COMMENTS ON SEQUOYAH FUELS CORPORATION'S
DRAFT RCRA FACILITY INVESTIGATIONS
WORKPLAN

March 10, 1994

COMMENTS ON SEQUOYAH FUELS CORPORATION'S DRAFT RCRA
FACILITY INVESTIGATION WORKPLAN

(FEI, Figure 97)

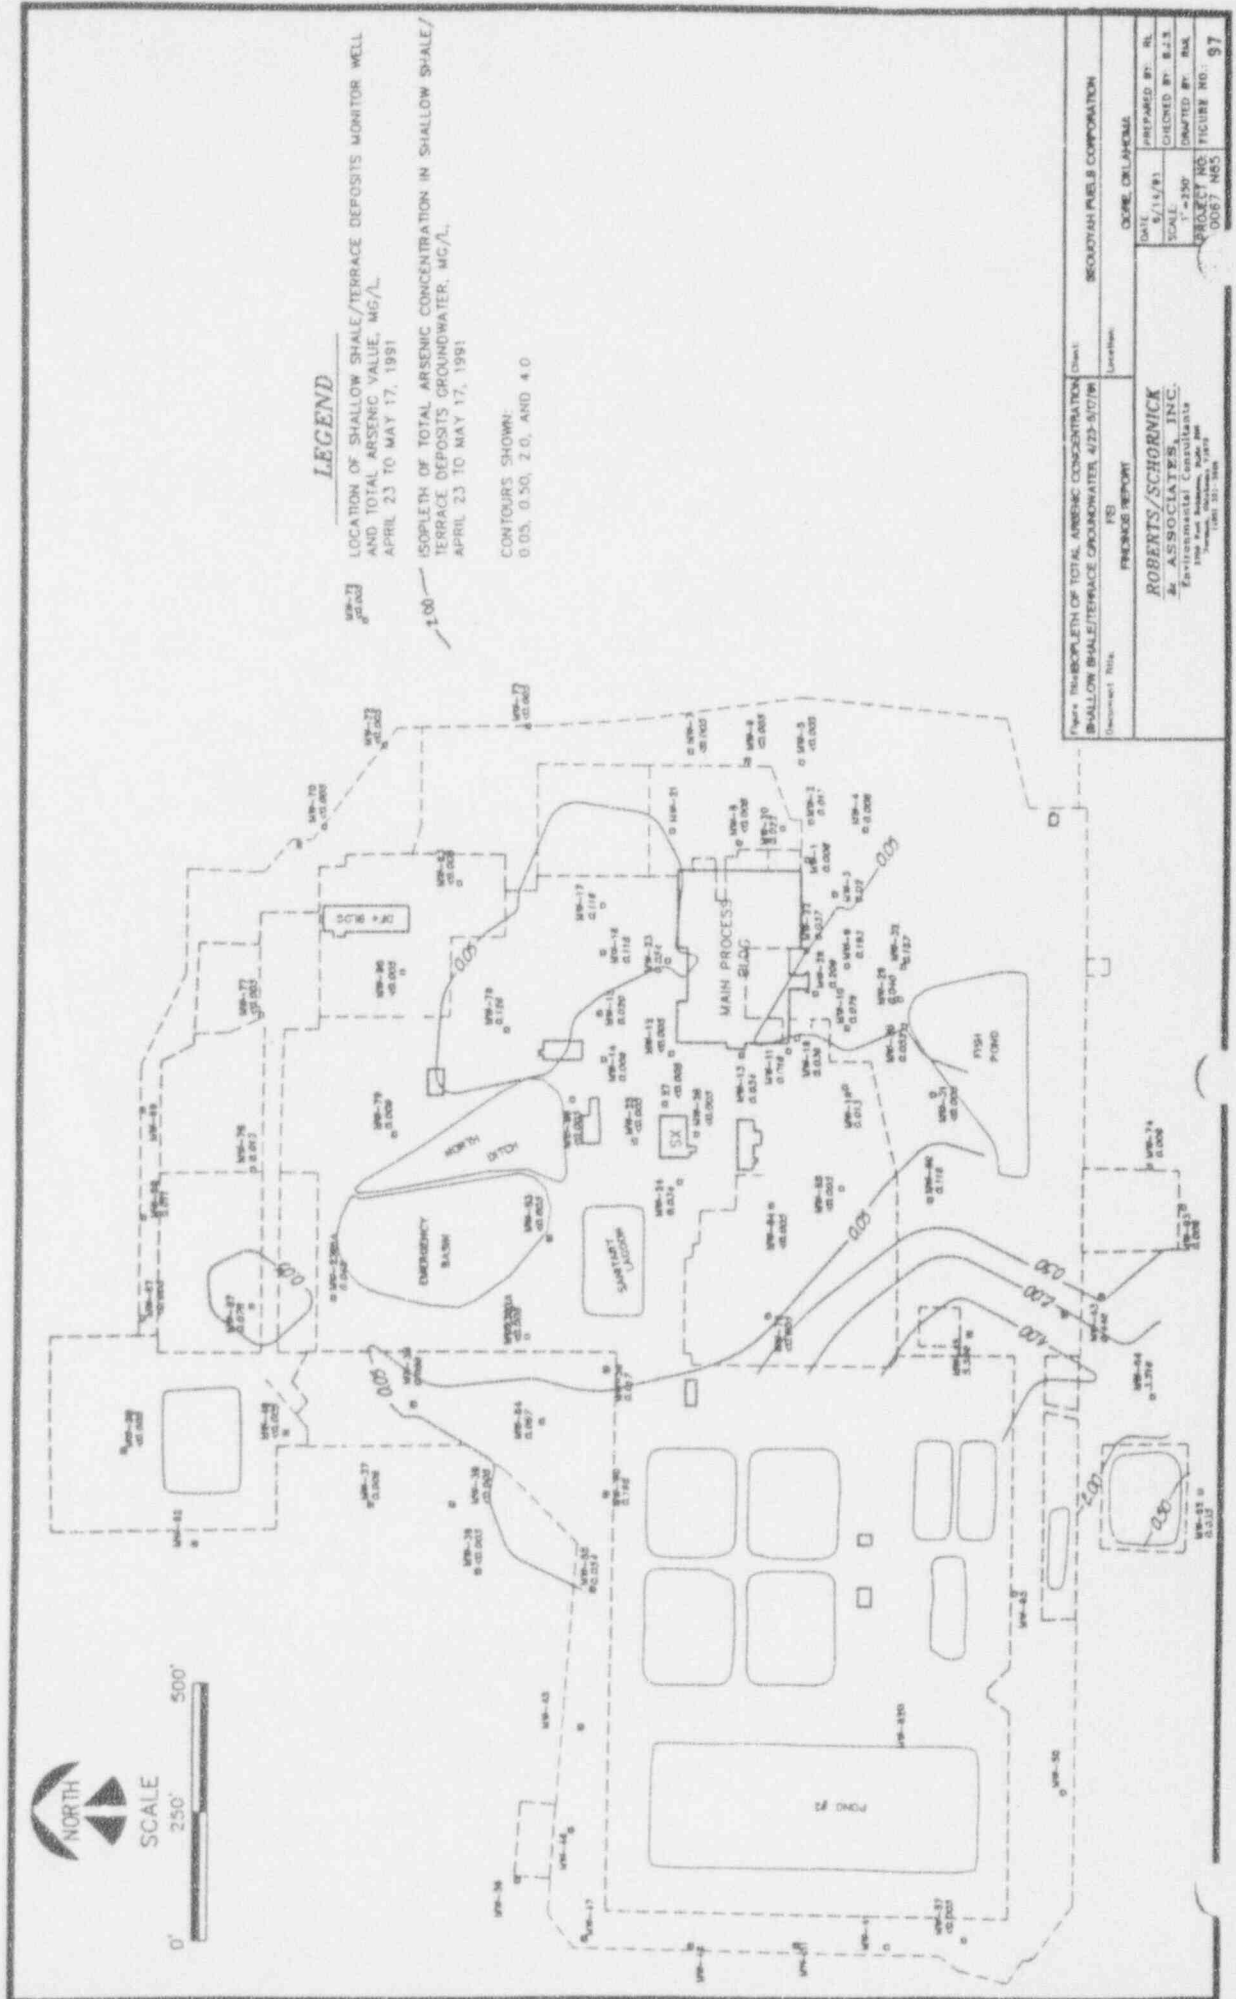
Comparison of Figures 77, 97, and 98 in the FEI (attached) with Figure 8 in the RFI Draft Work Plan, indicates both an insufficient number of monitoring wells and selection of monitoring well locations which will not detect the extent of hazardous material contamination. The RFI Draft Work Plan chooses four sets of wells in the vicinity of Unit 1 (MW3, MW20, MW11, and MW30) which all are below or at the Target Value for arsenic, yet other monitoring wells closer to the source (MW9, MW10, MW28, MW29, and MW32 in attached FEI Figure 97) clearly indicate that the Target Value for arsenic in groundwater is likely to be exceeded.

shows that arsenic was placed in Unit 15A, a settling pond, at some time in the past. Examination of Figures 97 and 98 in the FEI shows that arsenic plumes exist below this study area. Yet, according to the plan, if the single sample collected from pond 15A shows arsenic below the Target Level, due to attenuation from flushing over time or simply sampling inaccuracy, no further study will be done. Obviously, this area requires further characterization. The incorporation of a three-dimensional, statistically valid, Phase I sampling plan as outlined above would eliminate such loop-holes.

SEQUOYAH FUELS CORPORATION		
RFI WORKPLAN		
STUDY AREA SAMPLE LOCATIONS		
STUDY AREA	DRAWING NO.	DATE
SA-1	RFI-SA-01	1/18/94
REV.	DATE	BY
FIGURE 6

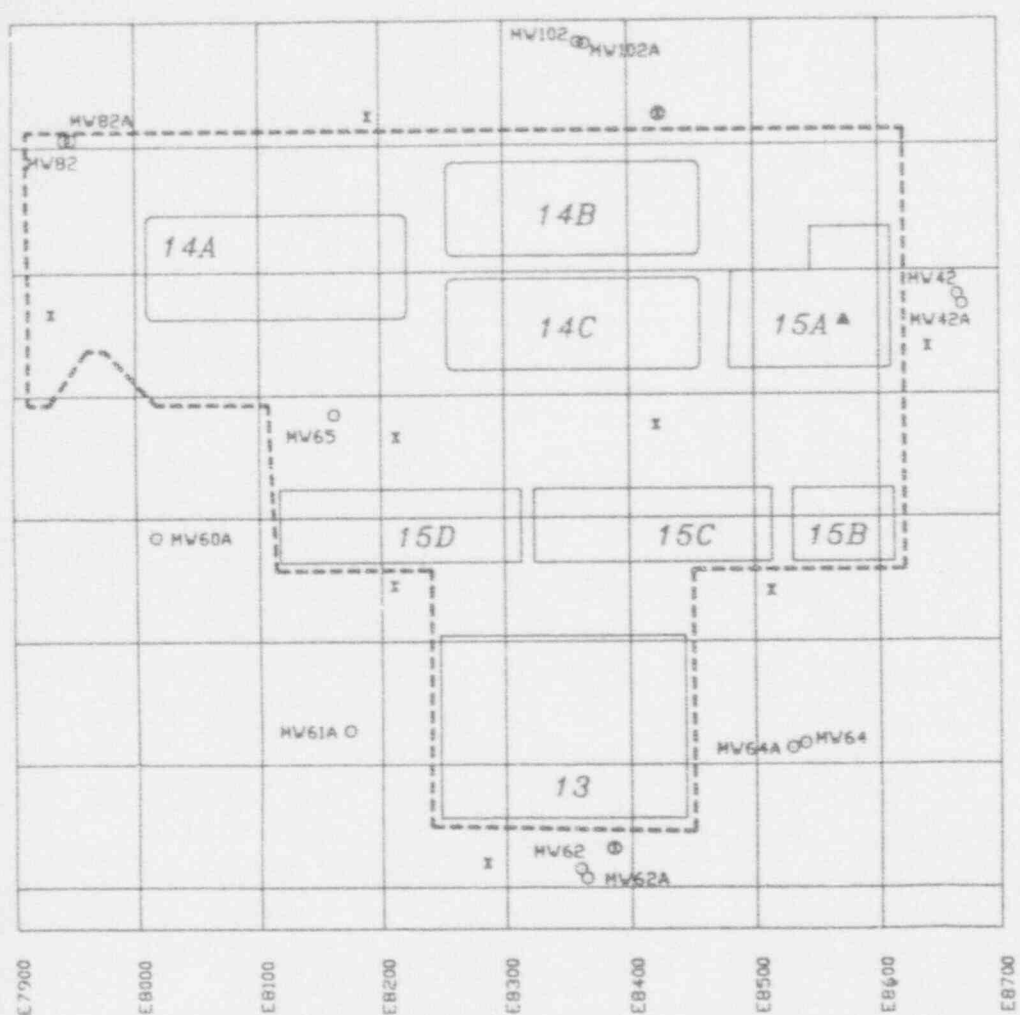
Study Area 1 (SA-1; p. 2-10) - SFC proposes to collect a single sample of sludge in order to characterize an area of about 2400 square feet. By any reasonable standard, this is not a statistically valid characterization of a potential source region. Soil or sludge sampling objectives for hazardous waste facility assessments include estimating the mean, variance, and confidence intervals of soil concentration levels (see Sara, 1993). This objective can only be obtained through the acquisition of multiple samples. Moreover, EPA should reject SFC's attempt to rely on previous sludge analyses from Units 13 and 14A-14C to characterize possible sources in Study Area 1, since SFC cannot demonstrate that the data collected prior to the RFI can be compared to the results of the one sample proposed to be collected within the RFI.

Additionally the Draft Work Plan provides for monitoring wells that are both insufficient in number and poorly placed for purposes of defining the bounds of contamination of groundwater downstream from the potential sources. For instance, the most likely source in Study Area 1 (Unit 15A) is approximately 300 feet upgradient from the nearest monitoring well (MW64A/MW64). Since flow velocity is on the order of 5 feet per year in the upper aquifer, contamination from the source is not likely to reach the monitoring well for about 60 years. Thus, such a distant monitoring well would not provide sufficient information about the extent of contamination emanating from the source. At least one additional well should be installed, closer to the source.

- Page 2-9: Section 2.2.1 outlines the study plan for Study Area 1. Here can be seen one of the weaknesses of the RFI strategy. The history of this study area

SEQUOYAH FUELS CORPORATION		
RFI WORKPLAN		
STUDY AREA SAMPLE LOCATIONS		
STUDY AREA	DRAWING NO.	DATE
SA-2	RFI-SA-02	1/18/94
REV.	DATE	BY
FIGURE 7

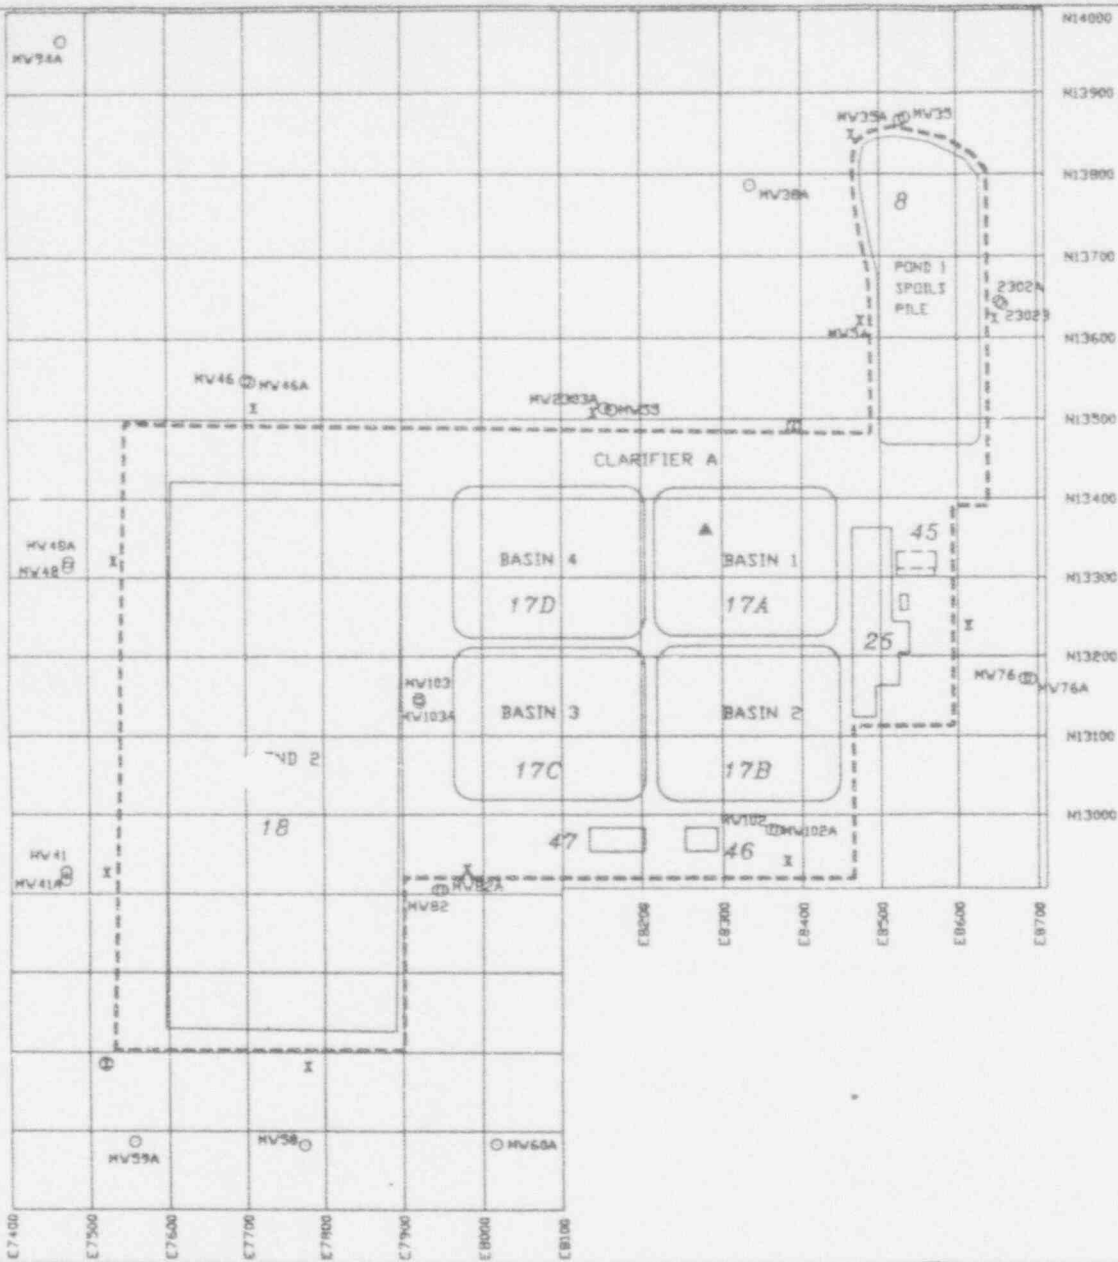
Study Area 2 (p. 2-14) - SFC's proposal for characterization of this study area has numerous significant deficiencies. First, SFC only plans to obtain one sample from a study

area containing 10 units which do not have the same operational histories and which contained different possible sources of hazardous materials. Second, the Draft Work Plan attempts to broadly apply the results of its single proposed sludge sampling in Unit 17A to other parts of the entire study area based on the assumption that conditions for the different units are essentially similar. However, SFC has not provided a documented basis or any rationale for such a comparison.

Finally, the location, depth, and number of groundwater monitoring wells for this study area are inadequate to define the extent of the arsenic plume at the southwestern boundary of Unit 18 (Pond 2) in the deep sandstone/shale system. This is borne out by the comparison of isopleths of arsenic documented in the FEI (see attached Figure 98) and the Draft Ground Water Monitoring Interim Measures Work Plan (GMIM; see attached Appendix H). The RFI Draft Work Plan proposes to rely on the same wells used in the FEI, yet the existence of open isopleths of arsenic well above the target value (by a factor of 40) indicate that insufficient information is available from these wells to determine the true extent of arsenic contamination. It is important to note that this groundwater plume of contaminant arsenic extends beyond the restricted area of the facility. In addition, since a groundwater plume of arsenic is not observed in the shallow aquifer system, this suggests that vertical migration of arsenic in groundwater has occurred. These observations imply that the boundary area of the study area is incorrect, and they reemphasize the importance of determining the vertical extent of hydrological transport of contaminants. SFC has not determined how deep groundwater contamination extends and cannot rely on its existing wells to make this determination (see attached comments of L. Lehman & Associates). The RFI Draft Work Plan provides no indication that SFC will determine the vertical extent of the contaminant plume.

- Page 2-12: Here again, in Study Area 2, a RCRA contaminant (arsenic) is known to exist above its Target Value within the groundwater. The Phase II media investigation will not be triggered unless arsenic is found at appropriate levels in the pond sediment. If this arsenic has migrated from Study Area 1 then arsenic would not necessarily exist in the pond sediment in Study Area 2 and this RFI Workplan would have no mechanism for characterizing the plume. A situation can easily be envisioned under this plan which might lead to no further study of this arsenic plume. If an attenuated source of arsenic existed at Study Area 1 which is not sampled above its Target Value and there are no other arsenic sources, then the RFI Workplan has no mechanism to detect or characterize this plume.

SEQUOYAH FUELS CORPORATION		
RFI WORKPLAN		
STUDY AREA SAMPLE LOCATIONS		
STUDY AREA	DRAWING NO.	DATE
SA-3	RFI-SA-03	1/18/94
REV.	DATE	BY
FIGURE 8

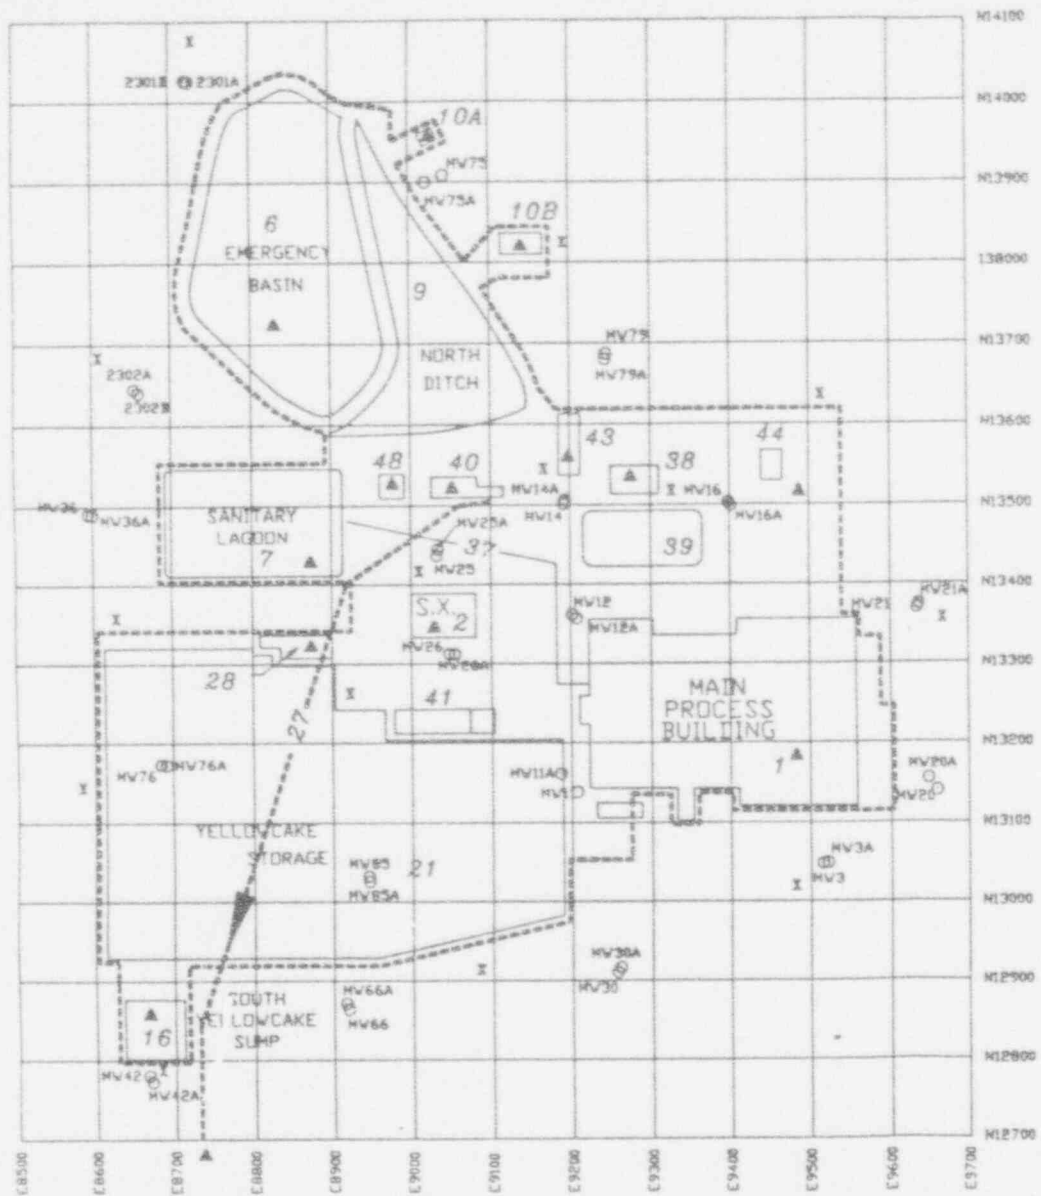
Study Area 3 (p. 2-19) - The stated objective of SFC's sampling effort for Phase I is to determine the concentration of Target Parameters in the material contained within a unit or study area. The RFI Draft Work Plan proposes to obtain a single sample from each different type of unit within the study area. However, the Draft Work Plan fails to provide sampling of several units (#9, #21, #39, #41, and #44) within this study area that are unique and thus need to be sampled in order to adequately assess the nature and degree of contamination. For instance, characterizing the tank farm at Unit #38 cannot substitute for characterizing the tank farm at Unit #39, because each unit has a different history and dates of usage. In addition, SFC does not propose to characterize the Yellowcake Storage Pad (Unit #21) at all, even though the EPA Administrative Order on Consent (Findings of Fact #19-21) clearly indicates that the area contains a variety of hazardous wastes.

- Page 2-15: Study Area 3 represents the most diverse and most intensely polluted Study Area on the site. This approximate 15 acre zone is covered by only 13 Phase I characterization samples. This sparse coverage does not insure that all existing RCRA contamination will be detected. A statistically valid sampling plan needs to be developed and implemented for all Study Areas.

FIGURE 10

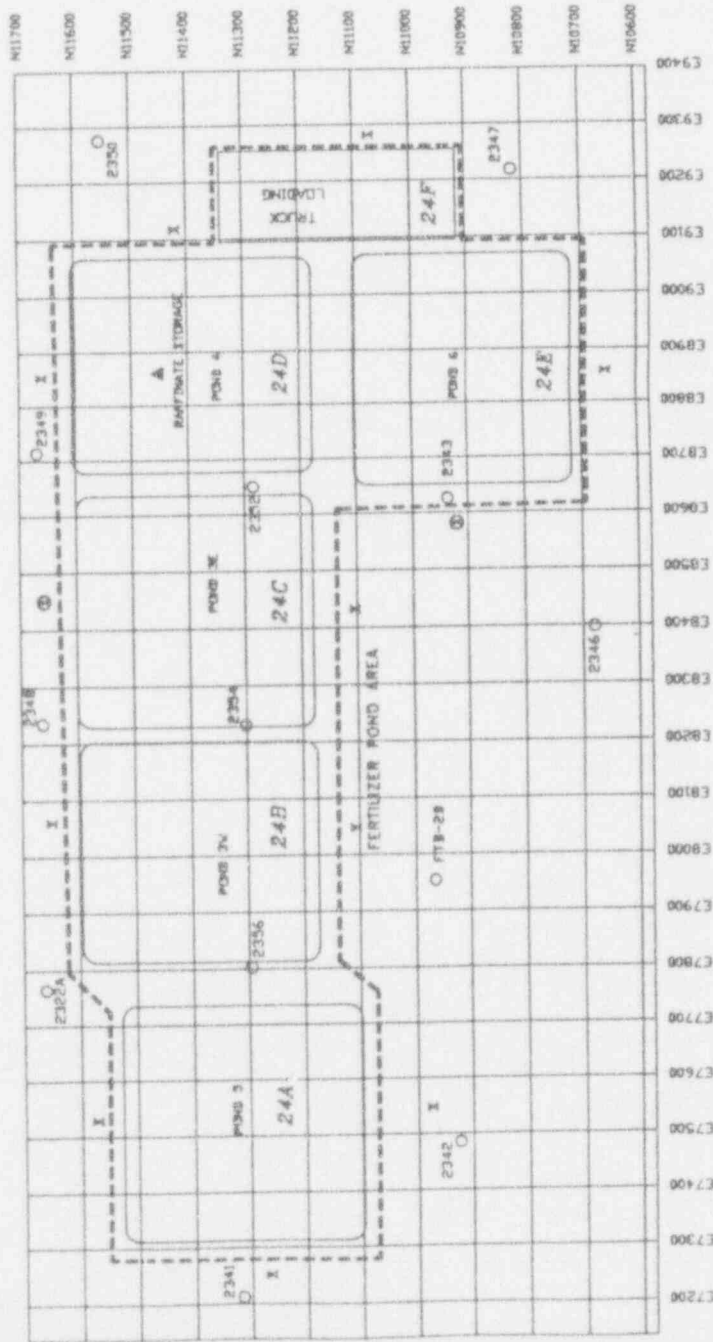
Finally, the Draft Work Plan's proposal for characterizing raffinate sludge in Unit 24D is utterly baseless. Although the Draft Work Plan states:

in fact, Unit 18 itself is not being characterized at all. Thus, it can hardly form the basis for characterization of Unit 24D. Moreover, the only sampling that SFC proposes for Unit 24D is a single test of the **liquid** portion and not the raffinate sludge:

- Page 2-23: For Study Area 5, a single sample will be taken from the "liquid portion of Unit 24D". These ponds south of the main processing area were used to contain raffinate which is known to contain low levels of RCRA contaminants. The sludge in these ponds should be expected to contain metals that settle out and accumulate at much higher levels than exist in the raffinate itself. The selection of a sample from the liquid portion of the Unit is not explained in the RFI Workplan and is a rather curious

choice. To insure that sources and contamination are detected and properly characterized the pond sediment itself should be sampled. Further, samples should be collected from all Units, as well as below and adjacent to these ponds. The FEI and other studies contain almost nothing relating to these ponds and so the RFI needs to contain provision for a complete characterization.

SEQUOYAH FUELS CORPORATION		
RFI WORKPLAN		
STUDY AREA SAMPLE LOCATIONS		
STUDY AREA	DRAWING NO.	DATE
SA-5	RFI-SA-4	1/18/94
REV.	DATE	BY
FIGURE 9

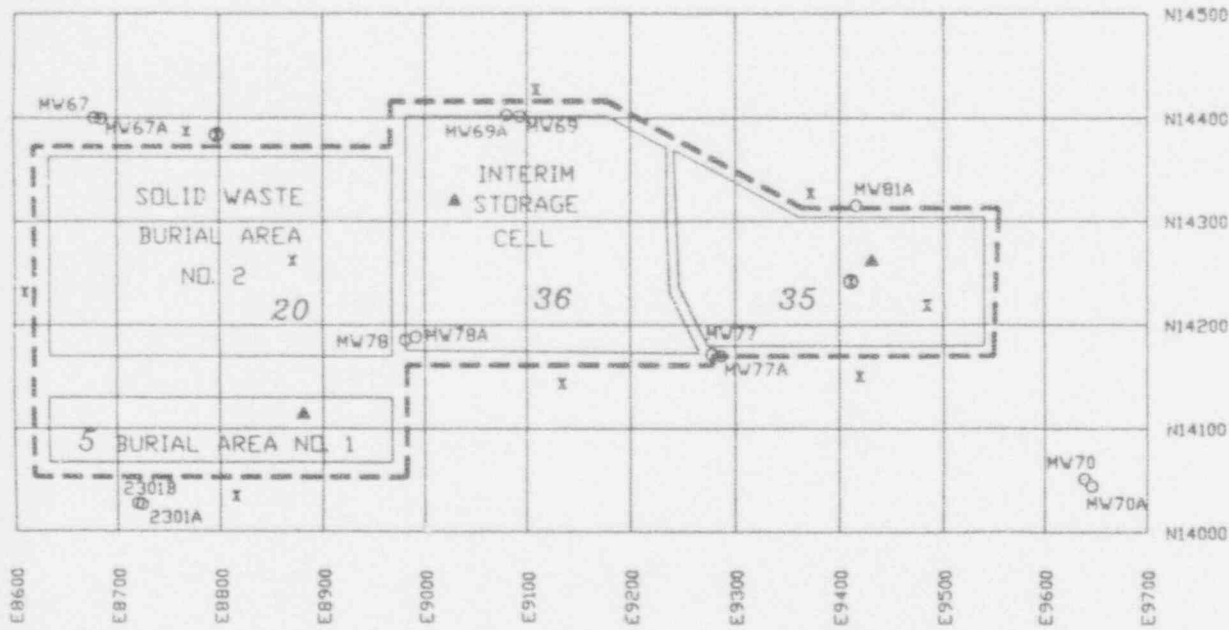
Study Area 4 (p. 2-22) - As with Study Areas 1-3 above, one Phase I sample is grossly inadequate to characterize a large study area (0.6 acre). Second, the Draft Work Plan's proposal for Study Area 4 highlights an additional problem likely to apply to several other units and study areas. This study area contains two units of known radiological contamination and possible hazardous contamination (i.e., arsenic in Units 5 and 20), one of which (Unit 20) is downgradient from the other (see attached FEI Figure 97 and GMIM Appendix H). However, there is only one monitoring well downgradient from the study area. Thus, it will be impossible to determine whether Unit 5 or Unit 20 is the likely source for non radioactive contaminants in groundwater above the Target Value. Accordingly, additional monitoring wells must be constructed within the study area.

Moreover, SFC's proposed sampling method for this study area will not result in statistically valid results. SFC states in the RFI Draft Work Plan that outlier values will not be included in summary data presentations or data evaluations. However, outliers could be important in Study Area 4 because variability of the concentration of uranium

and other possible hazardous constituents in the soil is on the order of a factor of 20. Based on the RCRA metal distribution being analogous to the uranium distribution in the soil within this study area, the three proposed samples to be collected during the RFI are likely to result in two samples having low concentrations of RCRA metals, while the third sample could contain substantially higher concentrations. Thus the three proposed sample locations are likely to result in one outlier (Unit 5). According to the inadequate information presented in Section 4.4.2, this one analysis, which is likely to show evidence for hazardous contaminants, would not be included in the summary data!
